IEC 62908-12-10
Edition 1.0 2017-06

Part 12-10: Measurement methods of touch displays – Touch and electrical performance

CORRIGENDUM 1

Figure 12 – Linearity definition

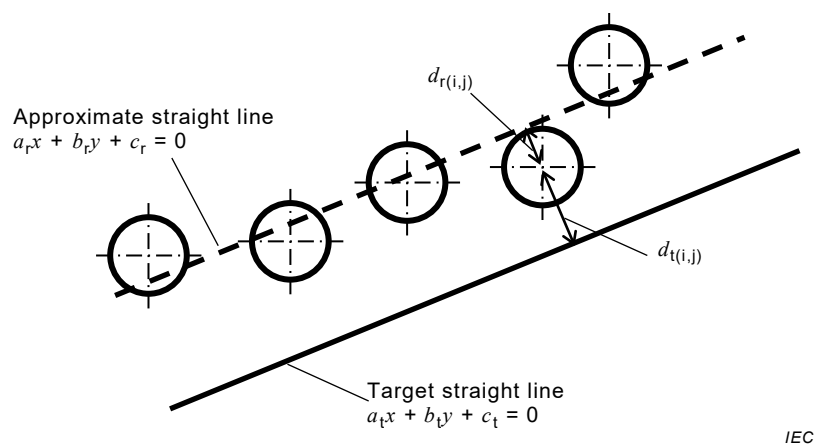
Replace the first sentence of the second paragraph with:

The distance between the centre of the reported point and straight line is calculated by the formula in Figure 12.

Replace Figure 12 with:

Replace Equations (17) and (18) with:

$$d_{r(i,j)} = \frac{|a_r x_{r(i,j)} + b_r y_{r(i,j)} + c_r|}{\sqrt{a_r^2 + b_r^2}} \quad (17)$$

$$d_{t(i,j)} = \frac{|a_t x_{r(i,j)} + b_t y_{r(i,j)} + c_t|}{\sqrt{a_t^2 + b_t^2}} \quad (18)$$
